**STAFF REPORT:** 4/12/23 REGULAR MEETING

**APPLICATION NUMBER:** 23-8232

**ADDRESS:** 4440 E. CANFIELD/4444 RUSSELL

**SCOPE:** ALTER FRONT PORCH OF RECTORY BUILDING

*Proposed work as shown in application. See application for additional images.*

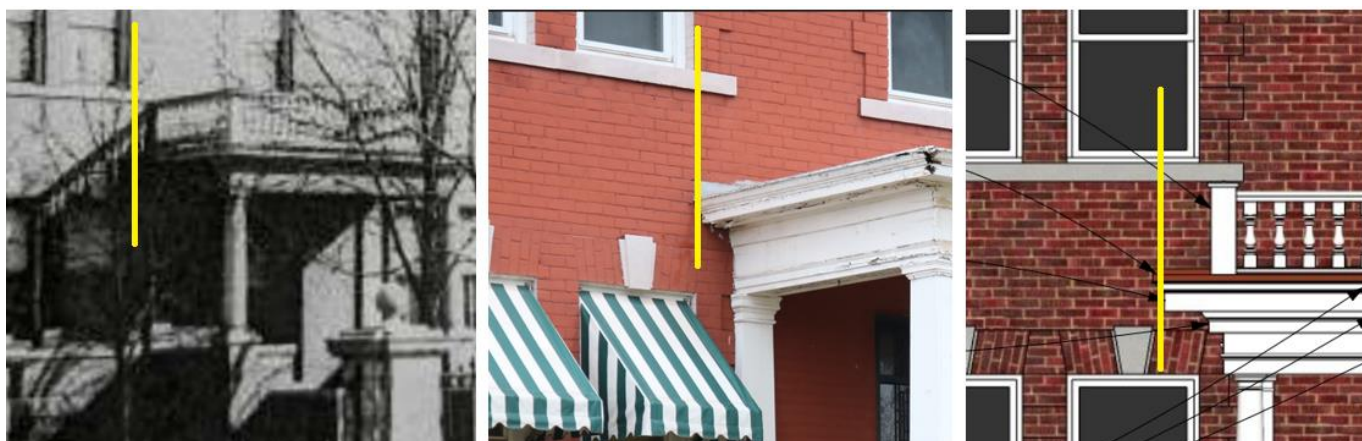
- It appears that the proposed wider porch roof is intended to provide clearance for drain scuppers located on the sides (north and south elevations) of the proposed new porch. Staff suggests that other mechanisms for drainage could be explored that would not require changing the dimensions of the historic porch.

- Staff notes that pure white is not an appropriate paint color. The Elements of Design specify light gray; Color System C provides several off-white color options for Colonial Revival and Neo-Georgian architecture. Staff suggests that the proposed color is acceptable as it matches the existing trim color of the building and retains the sense of contrast with the dark-painted brick; however, should the entire building be repainted in the future, an off-white trim color would be more appropriate.

*Left to right: Historic (from application), current (staff photo), and proposed (from application) porch; yellow line added by staff to indicate approximate western extent of porch cornice. Image is typical of both sides of porch as porch is symmetrical.*

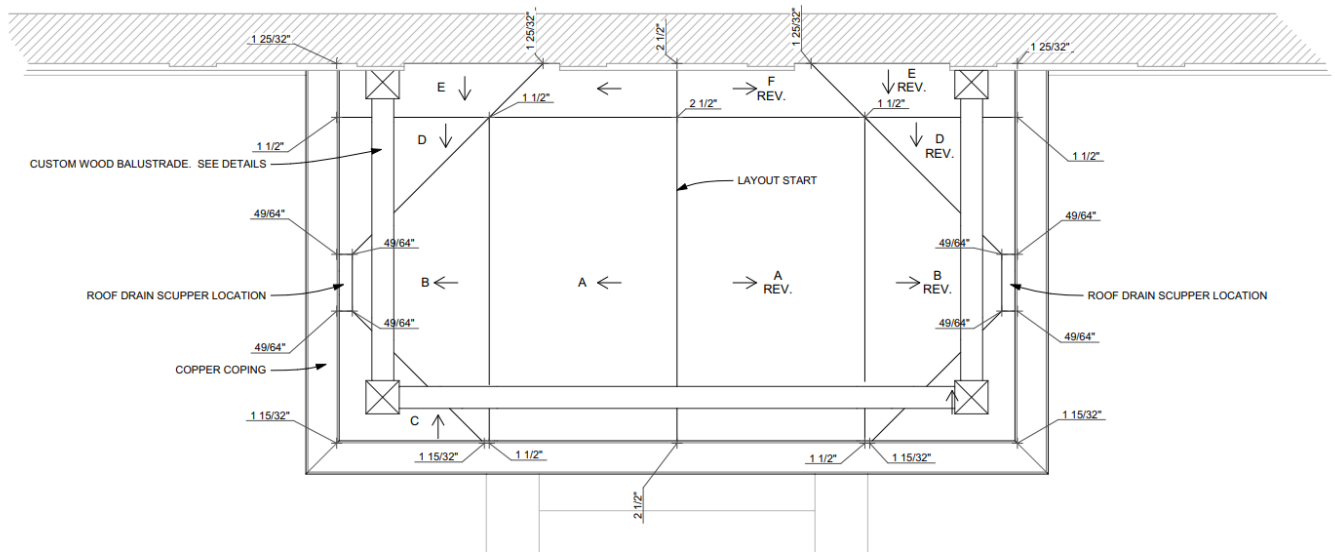
- The proportions of the proposed porch are clearly different from those of the historic porch. For example, the upper cornice of the proposed porch appears to be about two feet wider than the same element of the historic porch. The dimensions of the proposed porch would thus alter the visual relationship of the porch to the core facade. The proportions of the proposed porch entablature also appear to be changed from the current porch.
